Rezoning Transportation Analysis

Petition Number: 2022-192

Date	Description
3-22-23	First Review (TM)

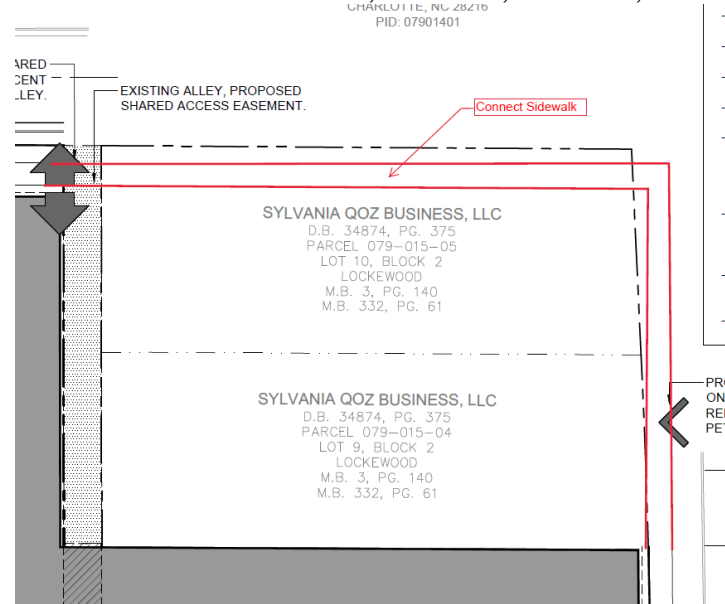
4. Revise site plan and conditional note(s) to commit to dedicate a minimum of 40-feet of right-of-way from the Tryon roadway centerline. The site plan shall label and dimension the right-of-way from the road centerline.

5. Revise site plan and conditional note(s) to commit to dedicate a minimum of 40-feet of right-of-way from the Dalton Street roadway centerline. The site plan shall label and dimension the right-of-way from the road centerline.

6. Revise site plan and conditional note(s) to commit to dedicate a minimum of 28-feet of right-of-way from the Dunloe Street roadway centerline. The site plan shall label and dimension the right-of-way from the road centerline.

7. Revise site plan and conditional note(s) to commit to dedicate a minimum of 36-feet of right-of-way from the Sylvania Avenue roadway centerline. The site plan shall label and dimension the right-of-way from the road centerline.

8. Revise site plan and conditional note(s) to commit to construct an 8-foot planting strip, and 8-foot sidewalk on all frontages per Chapter 19. The site plan shall label and dimension both items from the back of curb and gutter or edge of pavement.

9. The proposed dwelling units exceeds 12 per acre. Per Chapter 20 Subdivision ordinance, revise site plan and conditional note(s) to commit to construct an 8-foot planting strip, and 8-foot sidewalk along all public roadway frontages. The wider sidewalk also meets the Charlotte WALKS Policy.

10. Revise site plan and conditional note(s) to commit to construct bicycle facilities by locating the curb and gutter 38-feet from the Tryon Street center line and installing buffered bike lanes on Tryon Street to meet the Council-adopted Charlotte BIKES Policy.

11. Revise site plan and conditional note(s) to commit to construct bicycle facilities by locating the curb and gutter 35-feet from the Dalton Street center line and installing bike lanes on Dalton Street to meet the Council-adopted Charlotte BIKES Policy.

12. Revise site plan and conditional notes to commit to relocating the site access 20-feet from the property line in coordination with CDOT in the event that the neighboring property does not agree to a shared access agreement.

13. Revise site plan and conditional notes to state that final location of shared access alley to be coordinated during permitting.
14. Revise site plan by placing the 50x50 CDOT sight triangle and 10x70 NCDOT sight triangle in the proper location on the site plan.

15. Revise site plan and conditional notes to commit to revising existing curb ramps along site frontage to meet current standards. Landing strip/Truncated dome width must match width of sidewalk being installed.

16. **CDOT REQUEST from 03-23-23: CDOT request that the petitioner connects the proposed sidewalk to the intersection of Sylvania Avenue and Dunloe Street.**
